**Flood Control Project Maintenance
Levee Inspections**

Maintenance Issue Types Only, Levee Inspection Report By Mile - Spring 2020

Sutter Maintenance Yard Nelson Bend

Waterway	Bank	Unit Miles	Inspection Start/End	Inspector
Unit No. 01 Feather River West Levee - Nelson Bend		0.50	03/24/2020 03/24/2020	Sterling York

Photo 1 of 1 : SP_2020_ST0006_471_3_20200227_00003.jpg

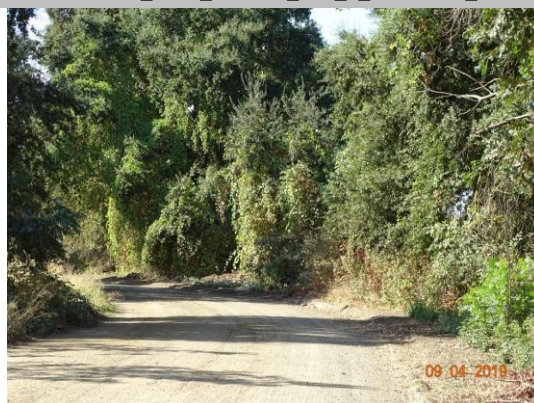
LM Start	0.13	Rating **	U	Issue No.	3
LM End	0.50	Issue Type +	Ma	Location *	LS
Category	Earthen Levee			GPS Latitude/Longitude	
				Start	End
Item	Trim / Thin Trees			38.885396 °	38.880295 °
				-121.615595 °	-121.614147 °
DWR ID	DWR_ST0006_01_f_2017_3				
Comment Code					
T3 : Trim and thin trees to allow visibility of the ground and room to flood fight.					
Inspector Comment					
Trim up the trees to 5 feet above the ground for access and visibility, Spring 2020.

View looking downstream landside of the over growth of trees.
